# **USB ENGINEERING CHANGE NOTICE – May 21 '12**

Title: HSIC ECN

Applies to: High Speed Inter Chip Specification, Rev 1.0

Figure 3a: Data Signaling Example with the raw data result(DENRZI) shown

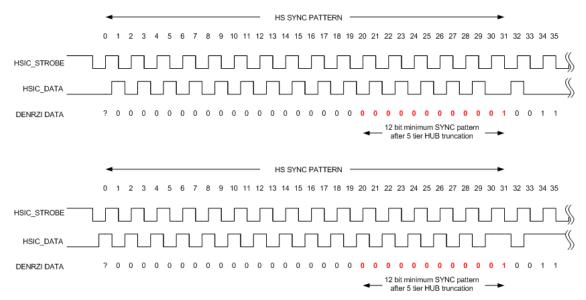
The HSIC receiver should be designed to be adaptive, meaning that the HSIC receiver does not filter packets based on a USB "J" or USB "K" encoding, but instead uses the decoded NRZI (DENZRI) and unstuffed data (the raw data). Please see the example below showing SYNC packet encoding and inverted encoding, and how the raw data is identical.

Example: The first pattern is an HSIC data pattern of (0101...0100). The second SYNC pattern is (1010...1011), the inverse of the previous pattern. In both cases the resulting raw data (DENRZI) is identical (0000...0001) which is a valid USB SYNC in both cases.

The reason for the adaptive receiver recommendation is that many USB PHYs are designed to qualify USB packets based on the DENRZI unstuffed data and the encoded repeater path data may not meet the above listed encoding requirements. Additionally, this will ensure that receivers maintain backward compatibility with any existing legacy HSIC devices that may transmit inverted data.
